Accessibility Report

VIFF Centre

April 2022

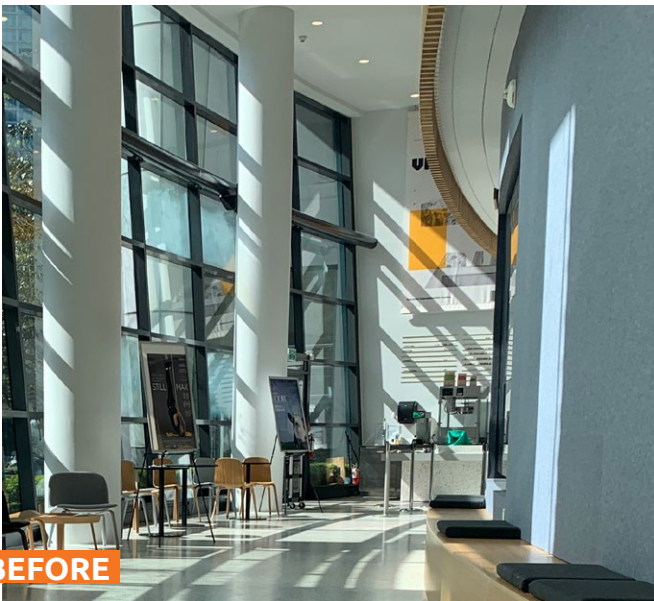
- **Glazed walls and doors**

Currently, glazed walls and doors lack any contrasted markings or stripes. This is a hazard and barrier for people with low vision, who may not detect the glass or have trouble differentiating between the doors and walls.

- **Blade signage**

Currently, there are entrances to the theatres that are reachable via long hallways, without directional signage. This is a barrier for people with low vision or stamina issues, who may benefit from knowing for certain where the theatre entrances are located.

Left: Glazed doors do not have markings or strips to indicate their presence.

Left: Theatre entrances are not visible from the corridor.

Consider installing two contrasted strips at two levels on glazed doors and (where appropriate) walls.

Consider blade signage that direct users to the theatre entrances.

Right: Two colour-contrasted strips on the glazed doors. The higher strip is at a height of around 1500 mm AFF, with the lower strip around 900 mm AFF.

Right: Blade signage indicating where to go to reach the theatre door.

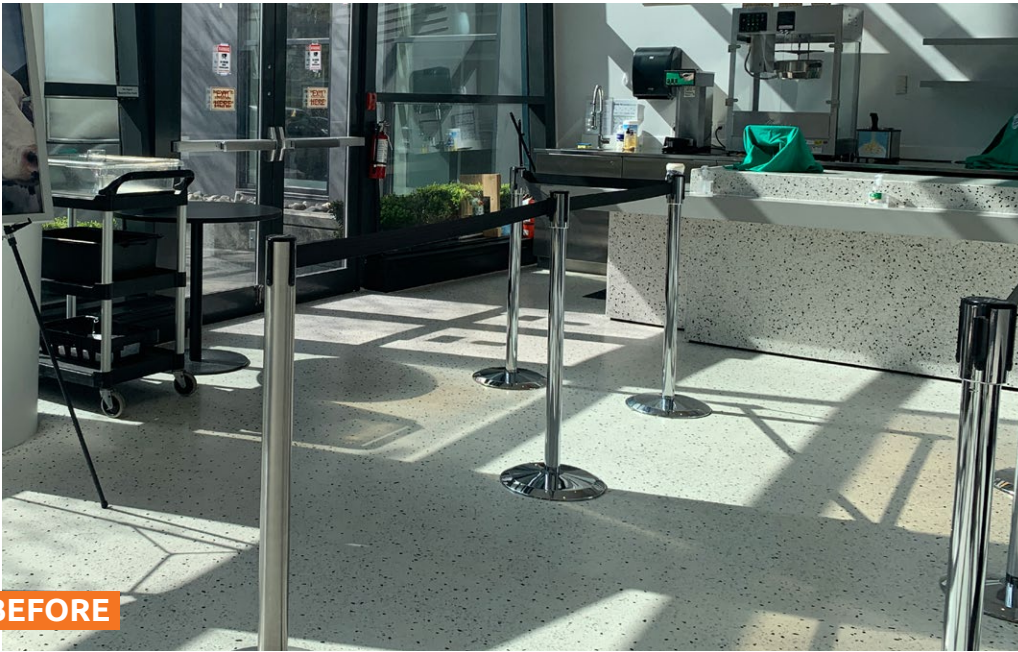
- **Queuing guides**

Currently for roped areas with queuing guides, only one height is available without colour contrast. This is a barrier for people with low vision, who may not be able to identify or detect the queuing guides with blind canes.

- **Interior stairs – nosing and riser strips**

Currently, some interior stairs do not have colour contrasted nosing strips. This is a hazard for people with low vision, who may have trouble differentiating between each step.

Consider queuing guides with colour contrast, available at two levels (lower ribbon at 685 mm AFF) to allow for blind cane detectability.*

Consider adding colour contrasted nosing and riser strips at each step.

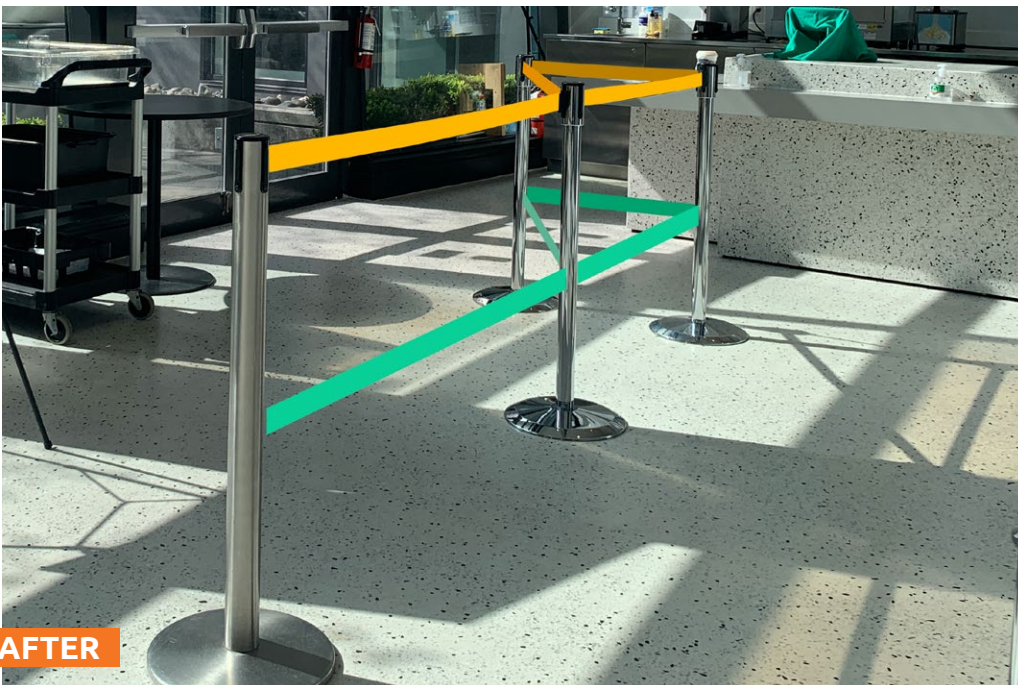
Top: Queueing guides are not colour-contrasted and at one height.

Top: Interior stairs without colour-contrasted nosing and riser strips.

Bottom: Two colour-contrasted ribbons at two heights. The bottom ribbon's height is 685 mm AFF or lower, to allow for blind cane accessibility.

Bottom: Colour-contrasted nosing and riser strips, visible while looking down and up the stairs.

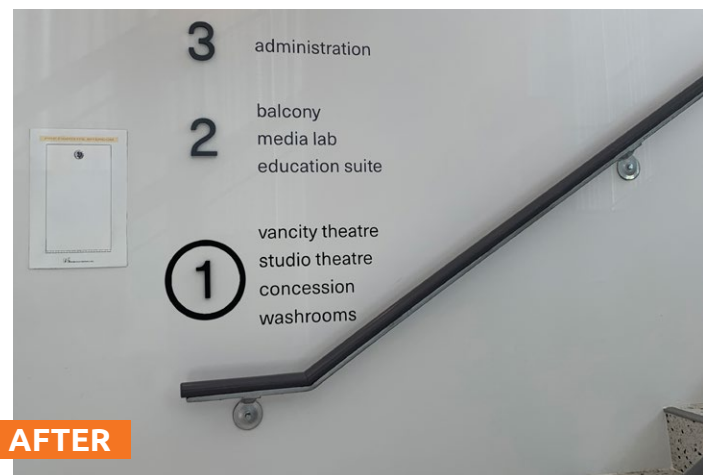
Left: Washroom signage lacks braille or raised lettering. Door is not power-operated or colour-contrasted. Directional signage may be hard to see from afar.

Left: Current floor is not indicated by a colour-contrasted visual cue.

Left: Washroom mirror is too high for wheelchair users. Towel and soap dispensers are too far or too high.

Right: Washroom signage has braille and raised lettering, with colour contrast. Door is power-operated via vertical actuator button, and colour-contrasted. Additional icons are added to directional signage, enhancing visibility from afar.

Right: Current floor is indicated by a circle around the floor number.

Right: Washroom mirror is lowered. Towel and soap dispensers are also lowered; the towel dispenser's height is around 1100 mm AFF and soap dispenser is around 950 mm AFF. (Heights are lower than usual due to clear space being obstructed by the sink.)

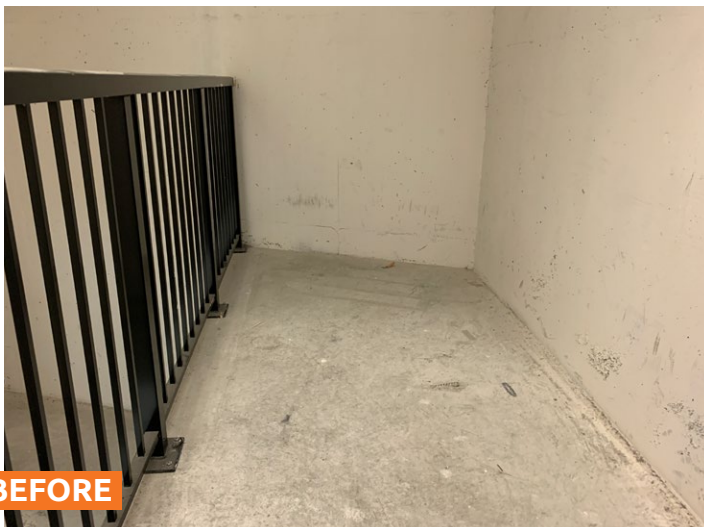
Left: Emergency exit doors have small text on signage, without icons. The door also has a high and narrow vision panel.

Right: Signage has icons and increased font. Vision panels now extend to the bottom of the door to enhance visibility.

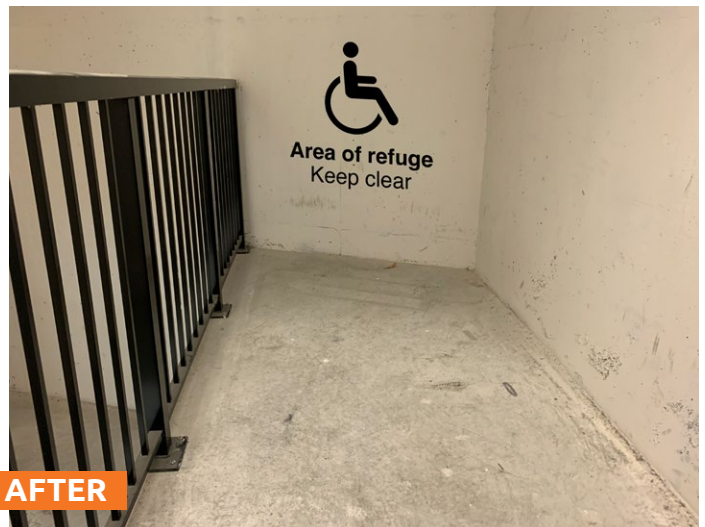
Left: Area of refuge lacks signage, which can prevent the space being used for storage.

Right: Area of refuge signage with both text and icons.

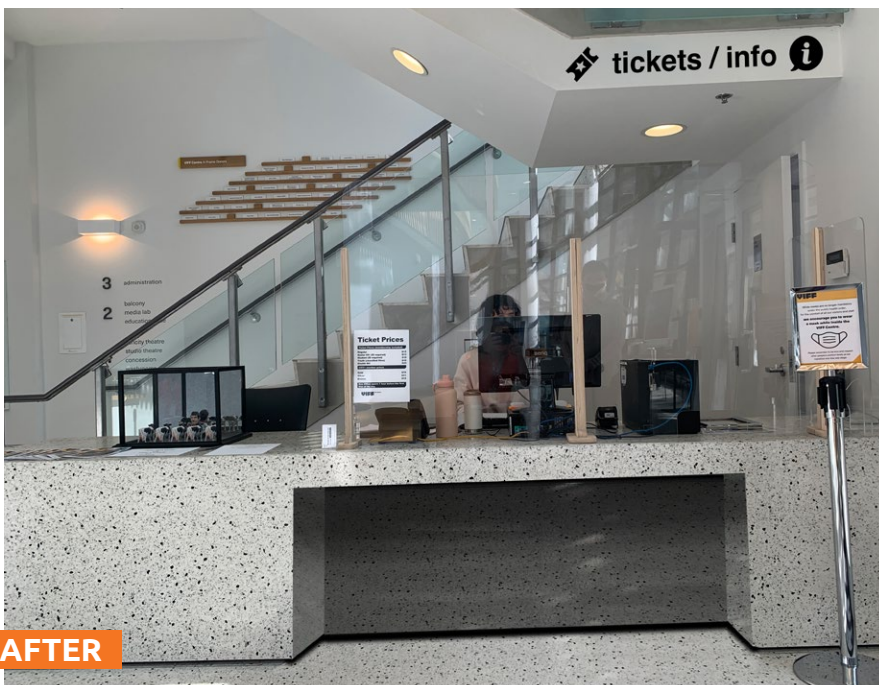
Top: Box office counter is available at only one height.

Top: Information desk has no knee clearance for approach by wheelchair users. There is no signage.

Bottom: Box office with a lower height for wheelchair users and those who are shorter. There should be a knee clearance height of 685 mm AFF.

Bottom: There is knee clearance underneath (685 mm AFF high and 200 mm deep). There is signage above the desk, with icons, colour contrast, and sans-serif typeface.

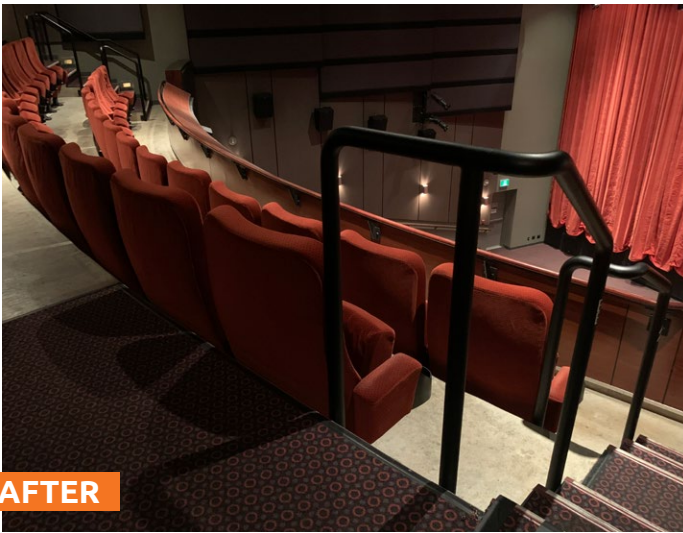
Top: Upper balcony does not have accessible seating options.

Bottom: Possible accessible seating, with a railing low enough not to obstruct the line of sight and a ledge to store phones, snacks, or other items. (The same idea may be applicable to the existing accessible seating below, if possible.)
